HAUS ESTATE SUBDIVISION

APPLICATION NUMBER 4 DATE December 5, 2019
 APPLICANT Haus Estate Subdivision
 REQUEST Subdivision

DETAIL SITE PLAN

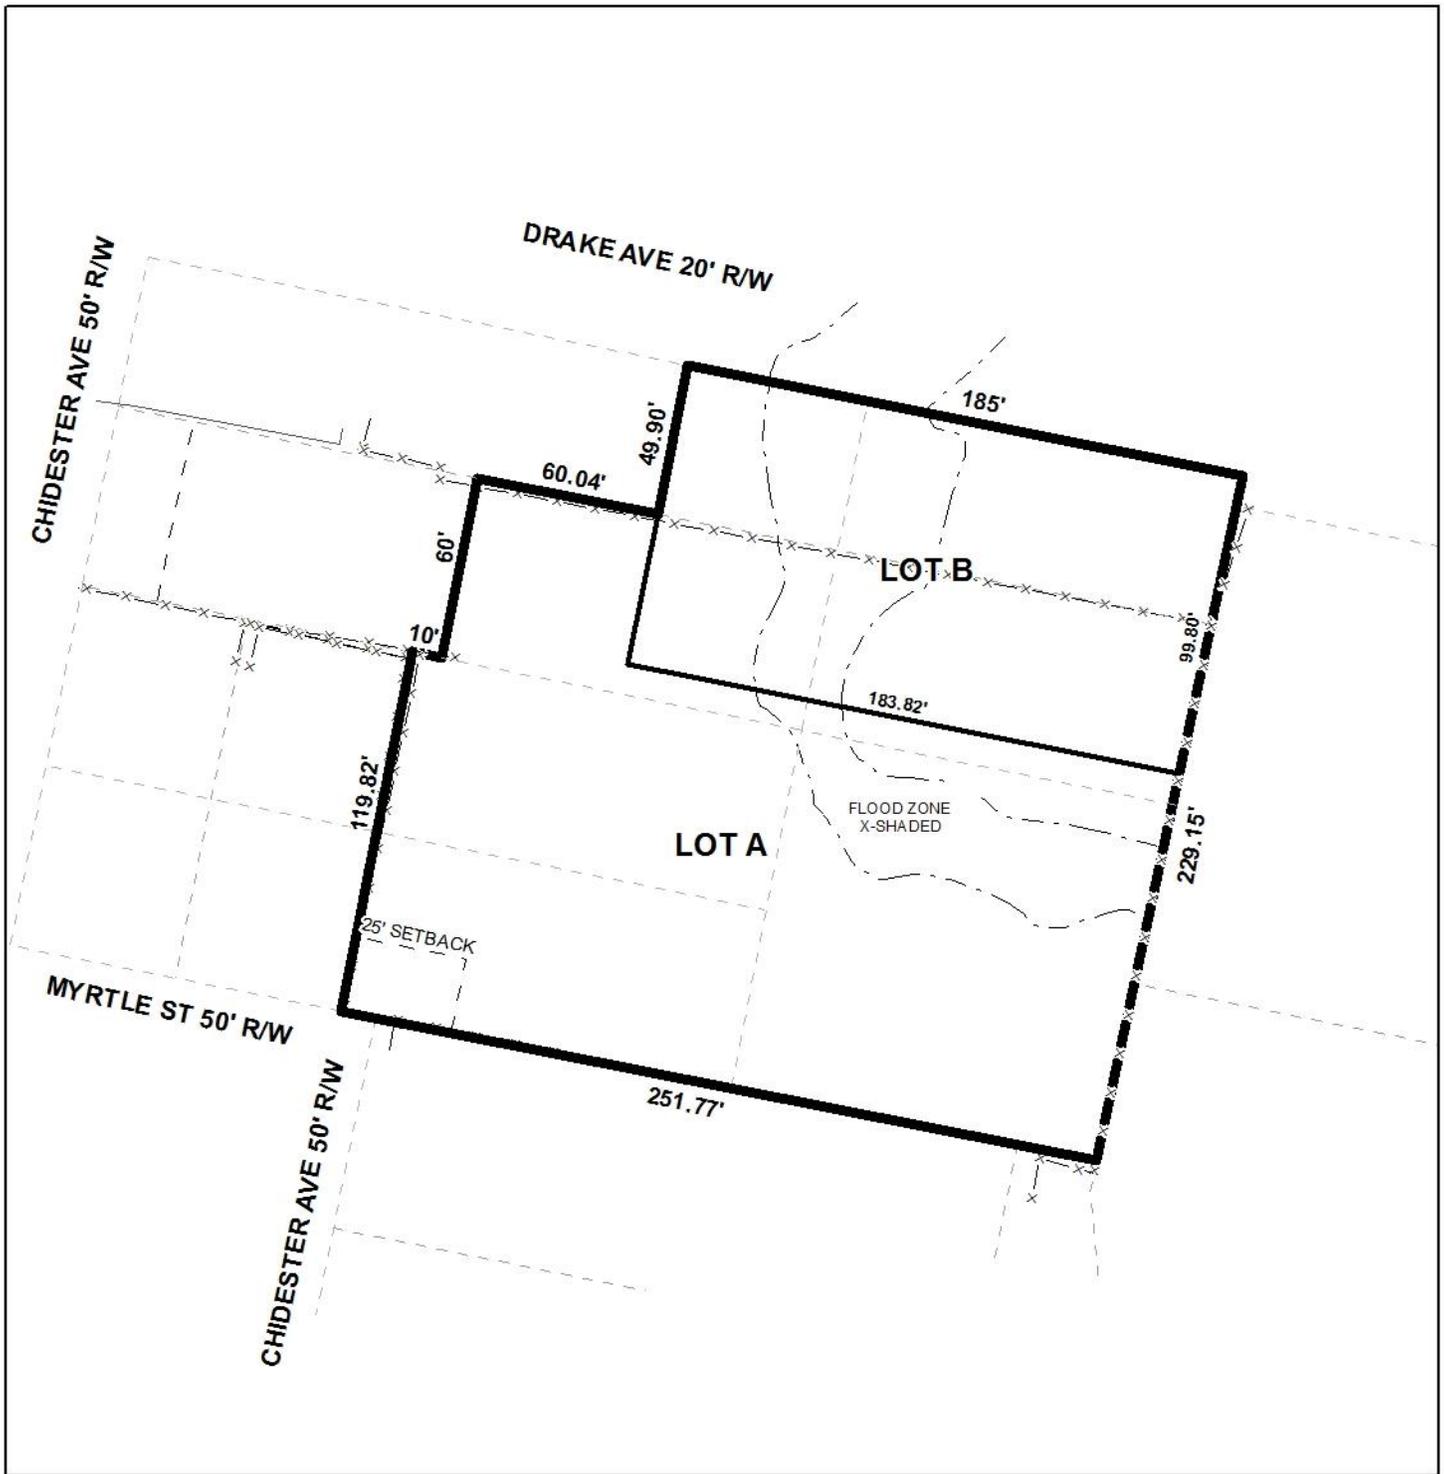
- B. Provide and label the monument set or found at each subdivision corner.
- C. Set reference monuments at the SE corner of LOT A where it is noted "UNABLE TO SET CORNER (FALLEN DEBRIS)".

- D. Show and label on the drawing all of the bearing and distances listed in the written legal description.
- E. Revise the signature block from "CITY ENGINEERING" to "CITY ENGINEER".

It should be noted that the preliminary plat erroneously labels Drake Street as Drake Avenue. This should be corrected on the Final Plat.

Drake Street is not curbed and guttered and has a substandard 20' right-of-way. Since a 60' right-of-way is required along streets without curb and gutter, dedication should be required along Drake Street to provide 30' from the centerline. However, if a survey indicates that the existing dwelling would then be within the dedicated right-of-way, an increased minimum building setback line of 45' from the existing right-of-way line would be allowable in lieu of dedication. If dedication is required along Drake Street, the plat should be revised to indicate a 25' minimum building setback line along Drake Street, as measured from any required frontage dedication.

The plat indicates a 25' minimum building setback line for Lot A blocked-out as measured from the 11'+ street frontage for that proposed lot. This should be retained on the Final Plat, if approved. As proposed Lot A currently has only 11'+ of public street frontage, a note should be required on the Final Plat stating that no further resubdivision of Lot A is allowed until sufficient public street frontage is obtained to allow such.

The lot size labels in both square feet and acres should be retained on the Final Plat, adjusted for any required dedication on Lot B, or a table should be furnished on the Final Plat providing the same information.

- 1) correction of the label of Drake Avenue to Drake Street on the Final Plat;
- 2) illustration of a 45' minimum building setback line from the existing right-of-way of Drake Street in lieu of frontage dedication if the existing dwelling would be within the right-of-way after dedication;

- 3) dedication to provide 30' from the centerline of Drake Street if such dedication does not place the existing dwelling within the dedicated right-of-way;

- 4) revision of the plat to indicate a 25' minimum building setback line along Drake Street, as measured from any required frontage dedication;
- 5) retention of the 25' minimum building setback line for Lot A blocked-out as measured from the 11'+ street frontage;

- 6) placement of a note on the Final Plat stating that no further resubdivision of Lot A is allowed until sufficient public street frontage is obtained to allow such;

- 7) retention of the lot size labels in both square feet and acres on the Final Plat, adjusted for any required dedication on Lot B, or the furnishing of a table on the Final Plat providing the same information;
